**FACILITY COMPLIANCE AUDIT REPORT**  
**Division of Waste Management**  
**Solid Waste Section**

Craggy Prison DOT LCID Notified Site  
 NC 251 (Riverside Road) to SR 1863 (Old Marshall Highway)  
 Weaverville, NC 28787

**PURPOSE OF AUDIT:** COMPREHENSIVE

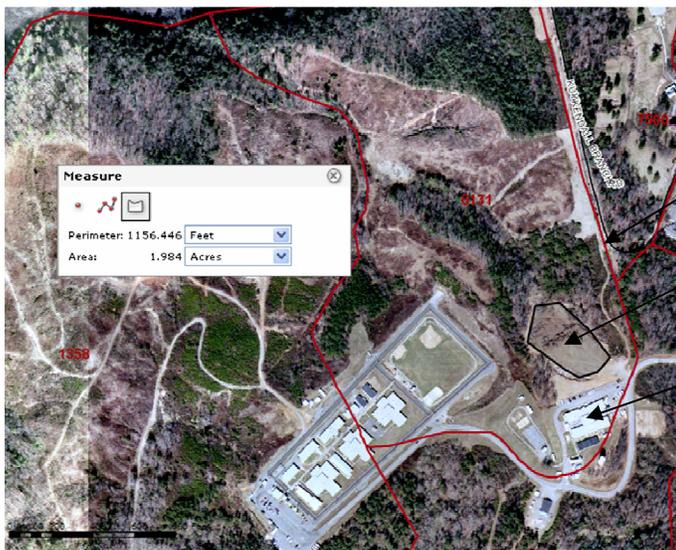
Per the 15A NCAC 13B .0566 Operational Requirements for LCID landfills, the facility shall be adequately secured by means of gates, chains, berms, fences, etc. to prevent unauthorized access in order to prevent disposal of unauthorized wastes. It did not appear that the facility had secured access.
